DESIGN REVIEW: Aegis West Seattle

FEBRUARY 4, 2016

DPD NUMBER: 3017747

ITEMIZED RESPONSE TO EDG

ITEMS FOR DIRECTOR'S APPROVAL: BICYCLE PARKING

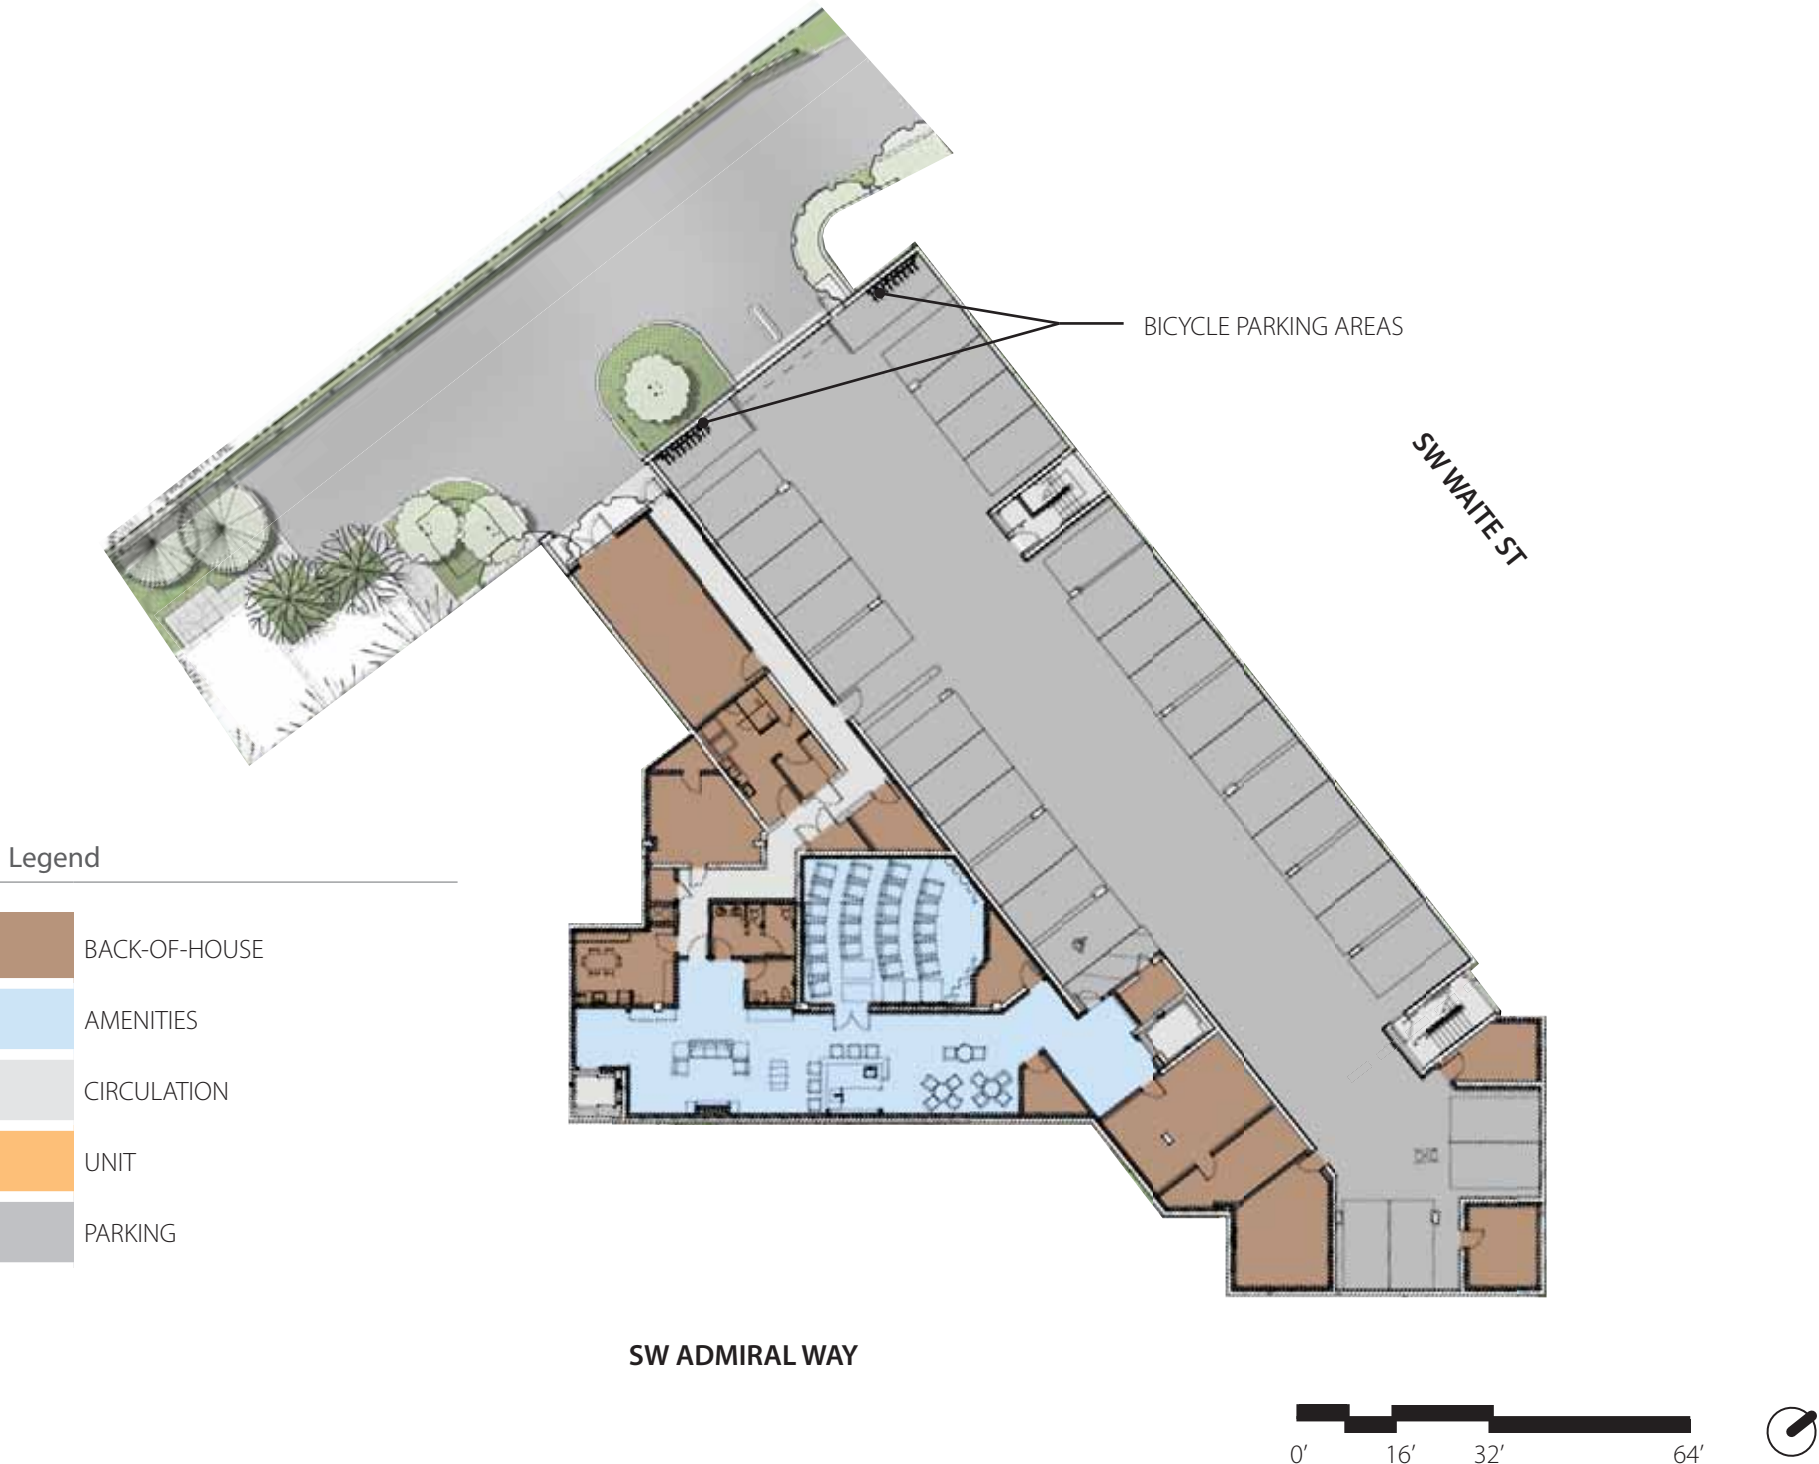
EDG Board Comments
"The board supports the request to provide 20 bike stalls rather than 55."

PROPOSED
(20) LONG TERM BICYCLE SPACES, OR AS REQUIRED BY THE DIRECTOR.

REASON FOR DEPARTURE
Residents of this building will generate little need for bicycle storage due to limited physical mobility. In addition, steepness of the site and traffic on Admiral Way do not offer assisted living residents a place to safely and comfortably cycle. For safety and security, the memory care residents do not leave the premises unescorted.

Proposed Driveway Section (adjacent to Existing Alley) - N.T.S.

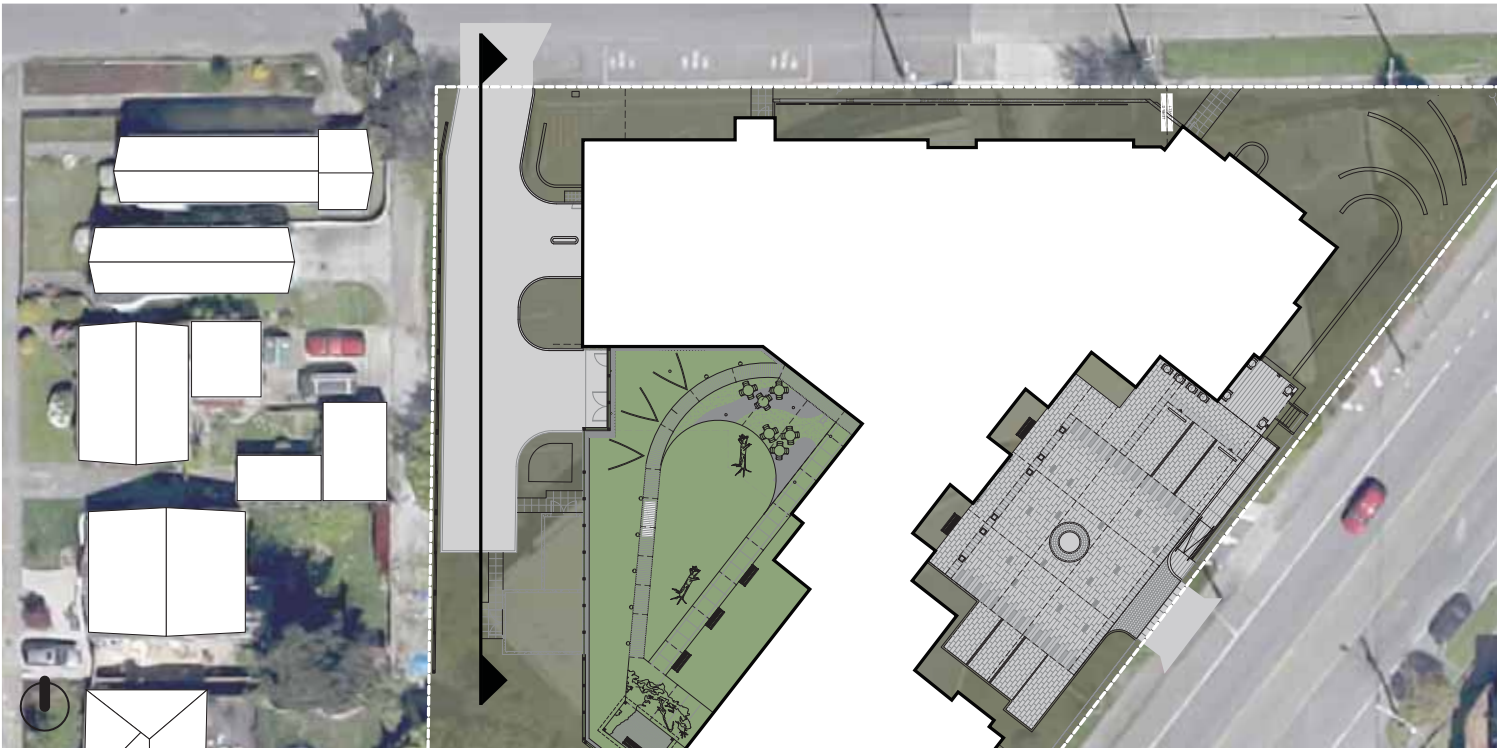
EDG Board Comments
"The board supports the request to provide a driveway slope of up to 20%. Adjacent existing alley to remain unchanged: exceeds 20% slope."

PROPOSED DRIVEWAY SLOPES 20% IN ACCORDANCE WITH REQUIREMENTS LISTED IN 23.54.030.D.3.a-c

Proposed driveway slope is needed due to site topography. Existing alley accessing neighboring properties slopes at 20.3%. Proposed new driveway to access project has a slope of approximately 20%. This is the least slope necessary for access, and should result in a usable driveway.

PLAN - RESIDENT & VISITOR DROP-OFF

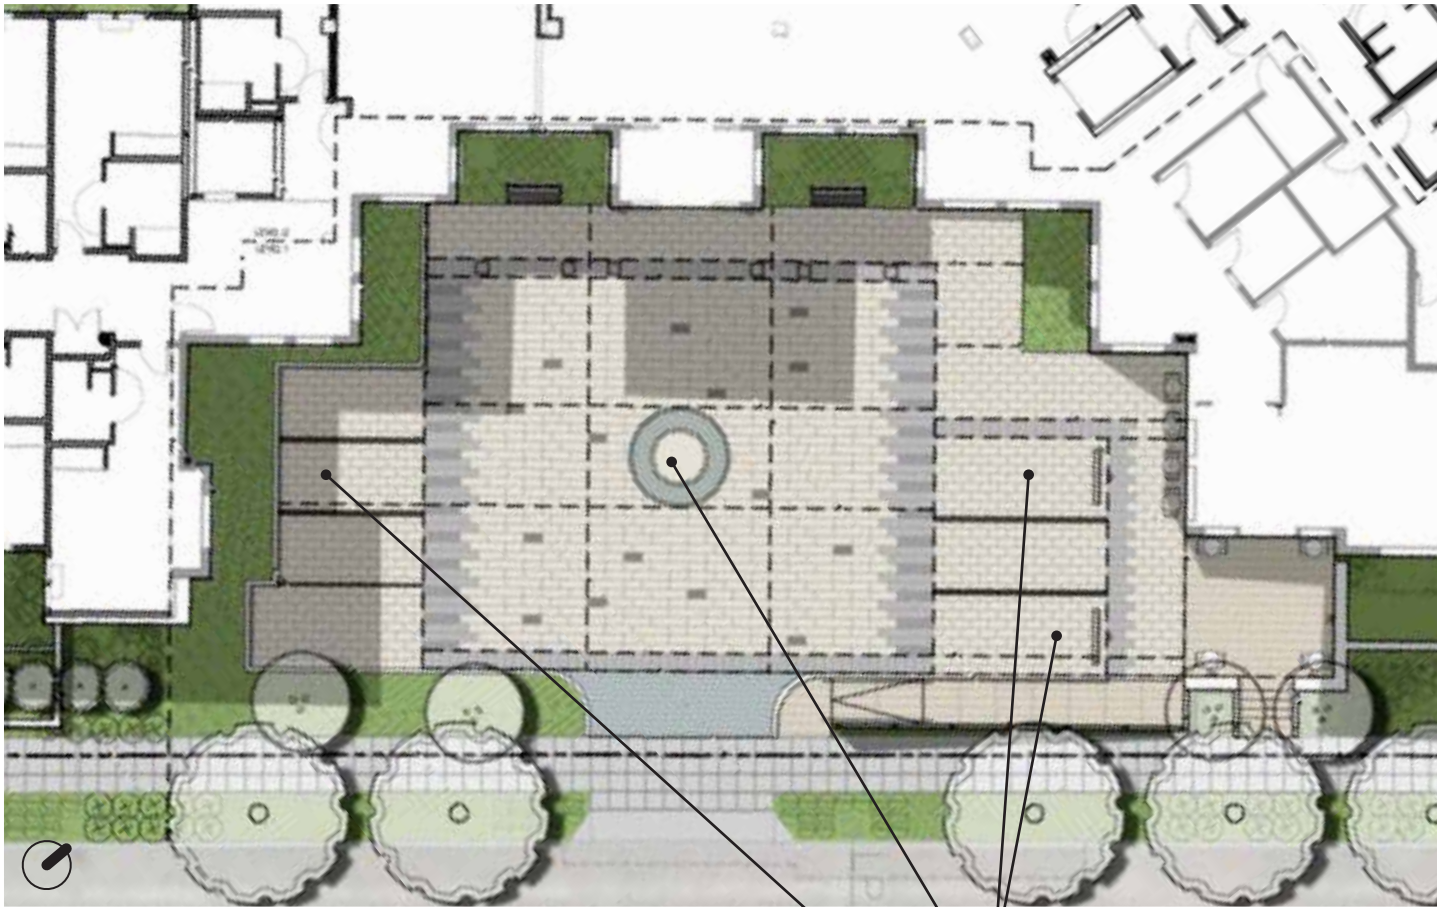
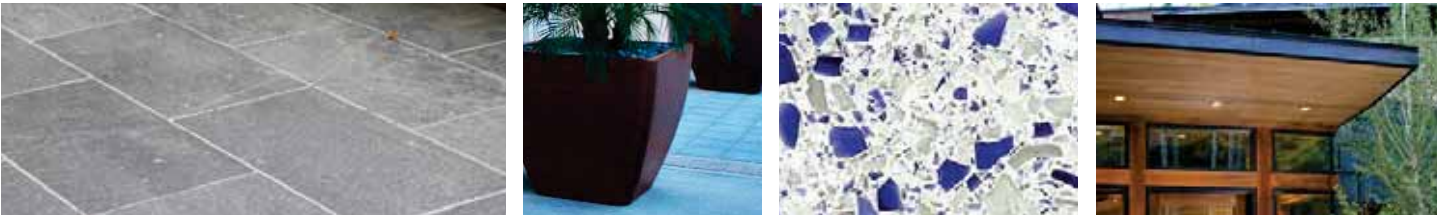
EDG Board Comments
"The board favors the departure to provide visitor parking and drop off at mid-block on Admiral provided there is the high quality materials and design rigor discussed in the presentation with regards to the articulation and details."

- High-Quality Materials
- Human Scale Details
- Articulated Facade
- Landscape Features

- 2 ADA PARKING STALLS
- DECORATIVE PAVING MEDALLION
- 4 VISITOR PARKING STALLS

Detail Section of Fence between Driveway and Alley

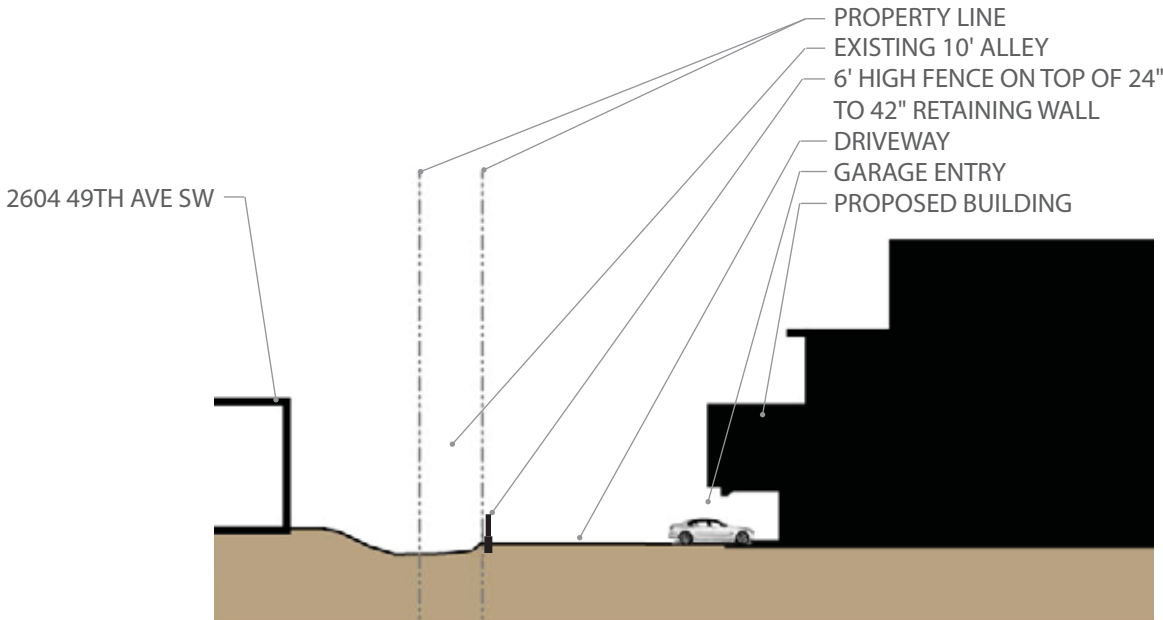
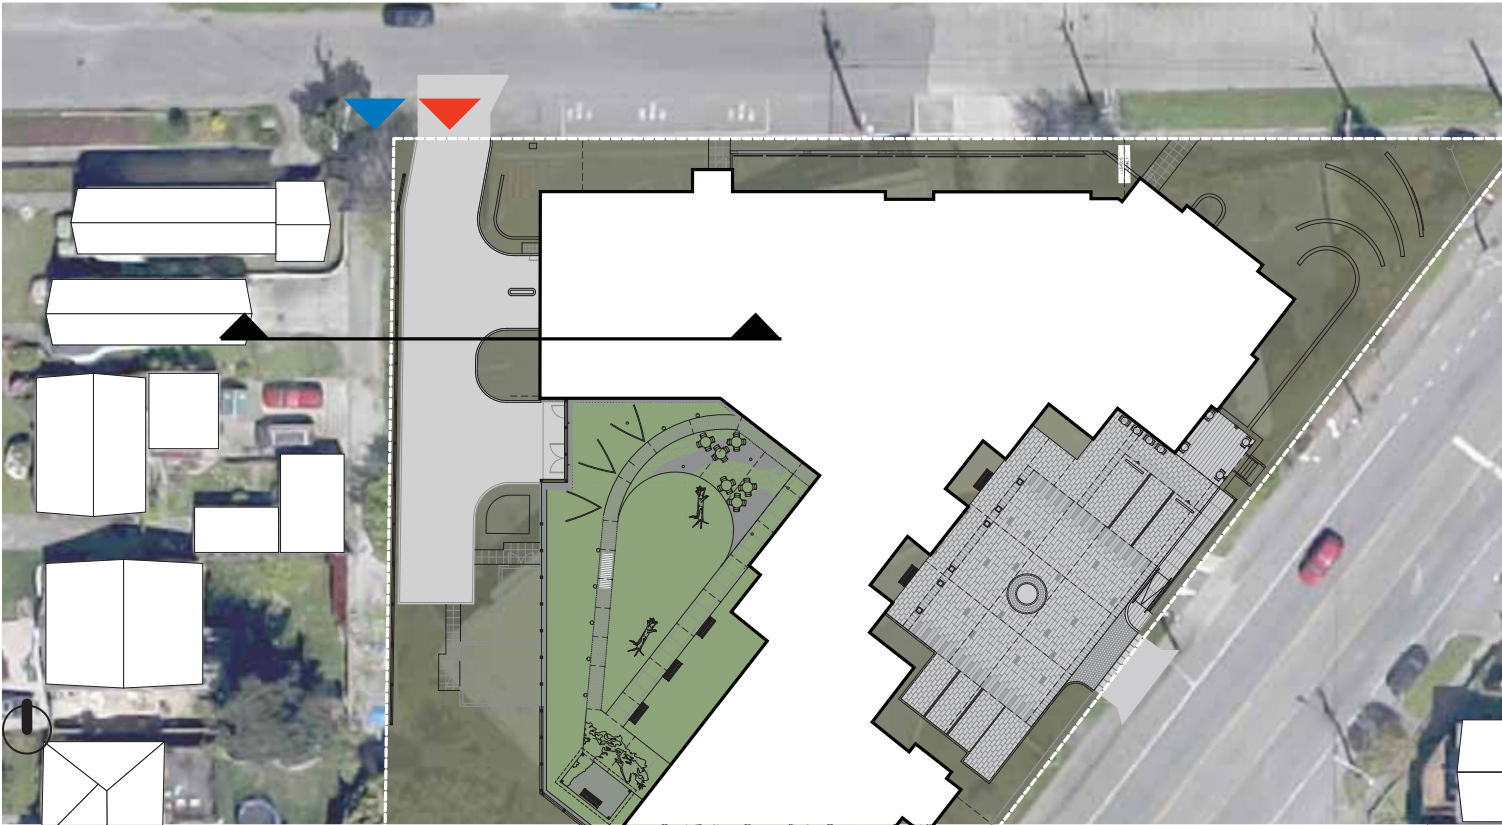
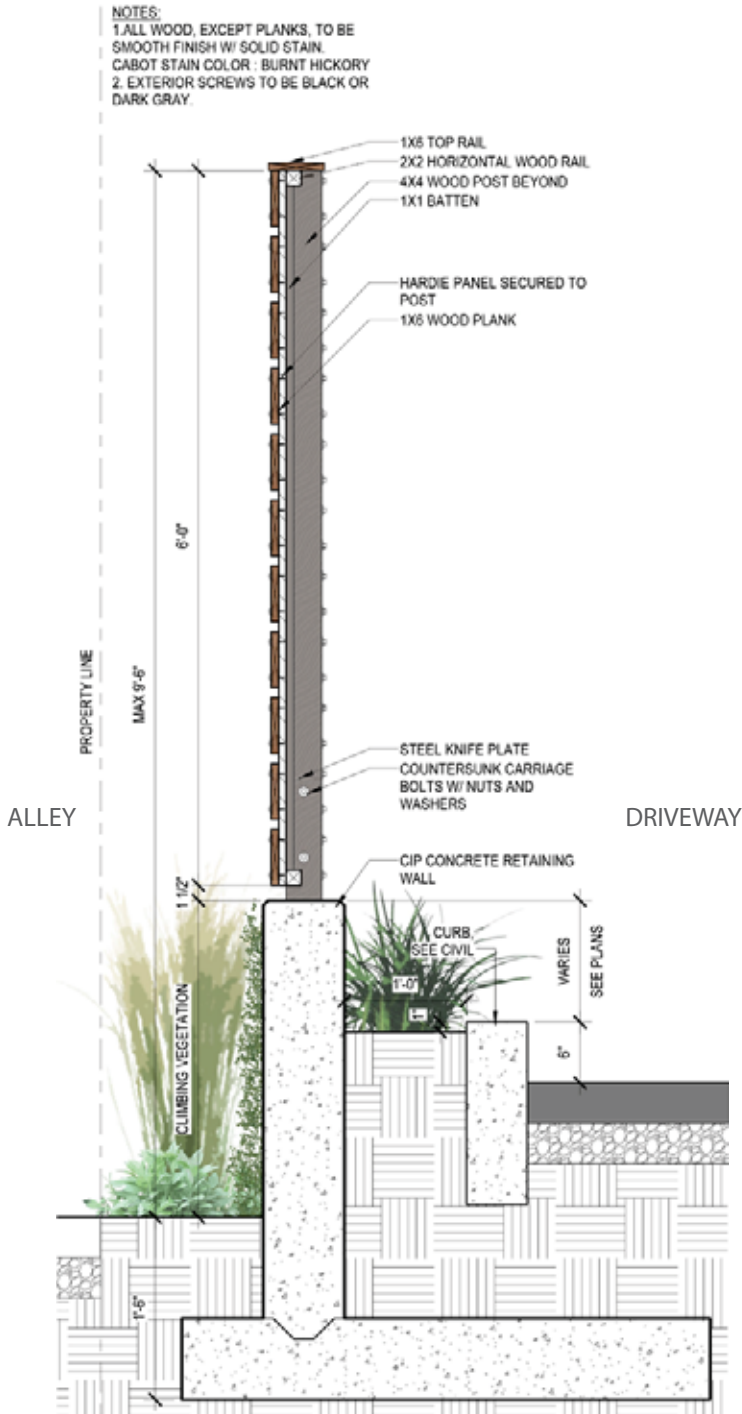
EDG Board Comments
NEW DEPARTURE; CONCEPT DISCUSSED AT EDG MEETING
(Related to Driveway Slope Director's Approval request and Driveway Development guidance)

23.45.536 PARKING LOCATION, ACCESS AND SCREENING C.1.	ACCESS TO PARKING: ALLEY ACCESS REQUIRED	PARKING GARAGE ACCESS VIA DRIVEWAY OFF WAITE ST, ADJACENT TO ALLEY	Access to the parking garage and loading dock is proposed via a driveway off Waite Street adjacent to the existing alley, which is similar to the existing condition. The existing alley is narrow and has a greater than 20% slope, whereas the project's proposed driveway will be wide and have a maximum 20% slope. The proposed driveway better supports safe and easy site access. Additionally, the proposed driveway is kept separate from the existing alley in consideration of the neighbors to the west who use the alley. They have requested visual and acoustic separation between the alley and the project's parking and service areas. The proposed driveway adjacent to the alley allows this to occur -- a 6ft fence on retaining wall and plantings are proposed -- while maintaining existing resident access of the alley.

Perspective at Waite looking down Driveway and Alley

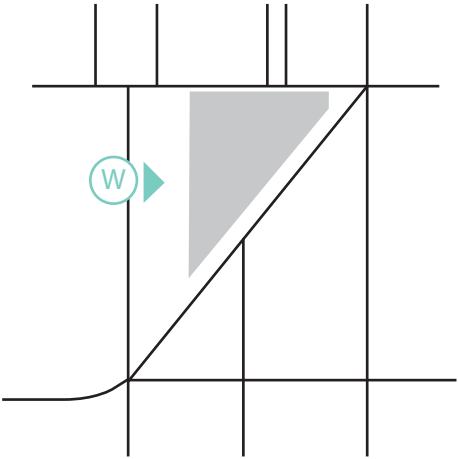
EDG Board Comments

Provide further development of the details of the separation between the driveway and the existing alley along the west property line:

- Explore options for the fence or screen along the property line
- Explore options for more acoustical isolation from noise associated from cars and trucks using the driveway
- Explore options for enclosing the loading dock, and generator

- Fence is 6' high atop a 2-3.5' high retaining wall along the length of the driveway
- Fence is made of attractive materials
- Fence and planting block light from cars exiting garage
- Fence and planting promotes visual privacy between site and neighboring houses
- Fence and planting, provide acoustic mitigation from noise associated with the driveway

Perspective from Northeast - SW Admiral Way & SW Waite Street

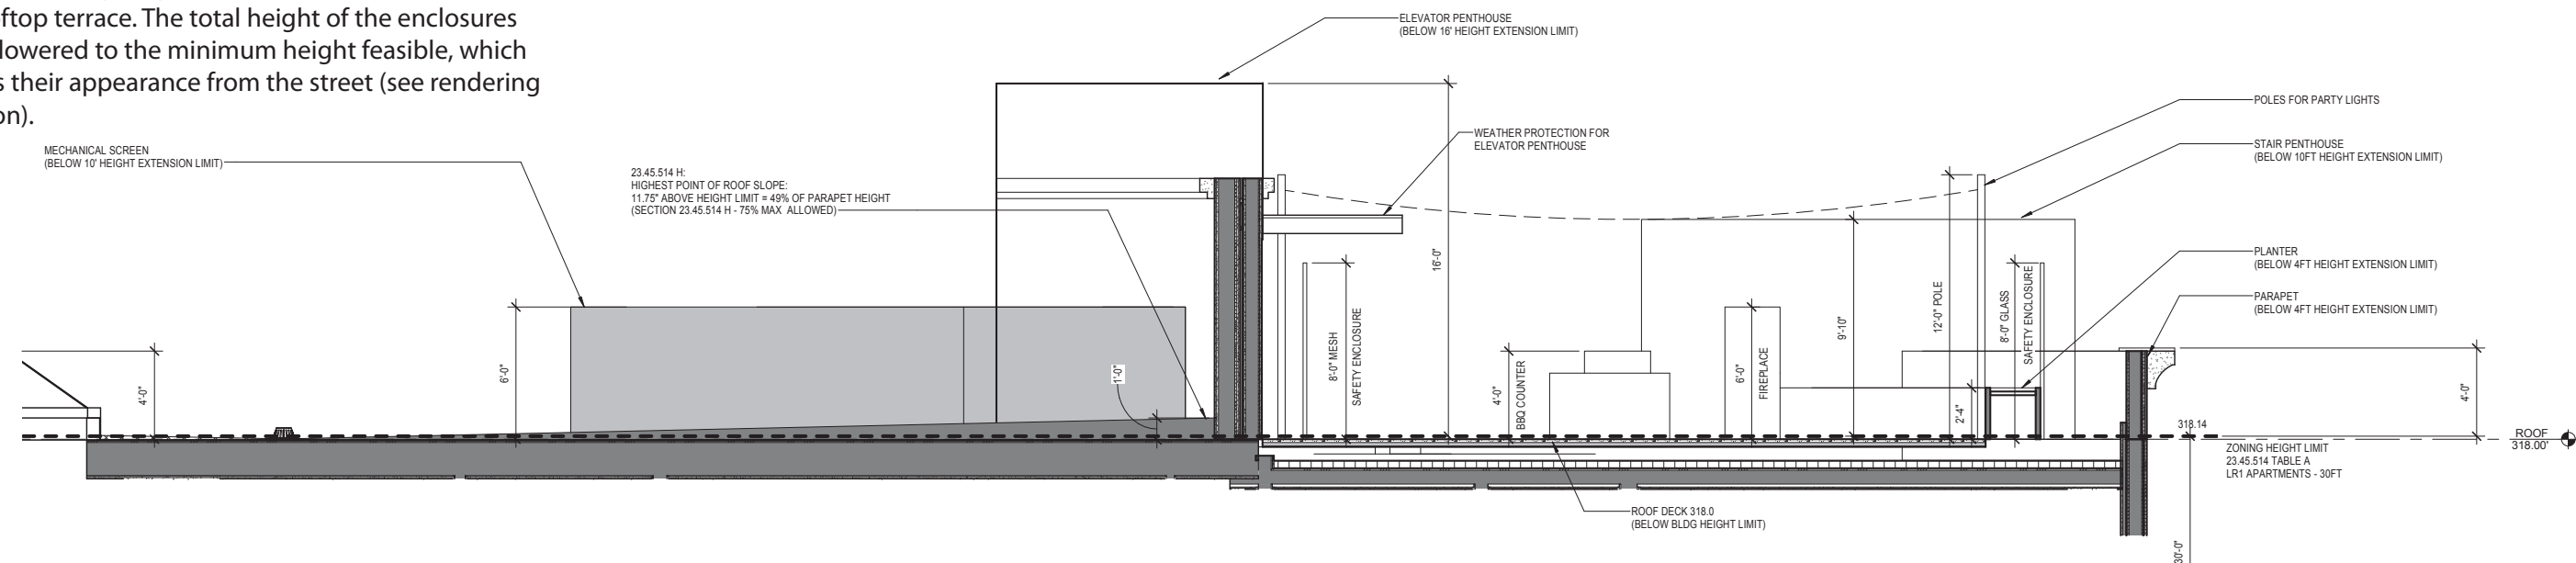
MINIMIZE ROOFTOP ELEMENTS

- Stair and elevator enclosures are allowed by zoning code to exceed the building height limit in order to provide access to the rooftop terrace. The total height of the enclosures has been lowered to the minimum height feasible, which minimizes their appearance from the street (see rendering and section).
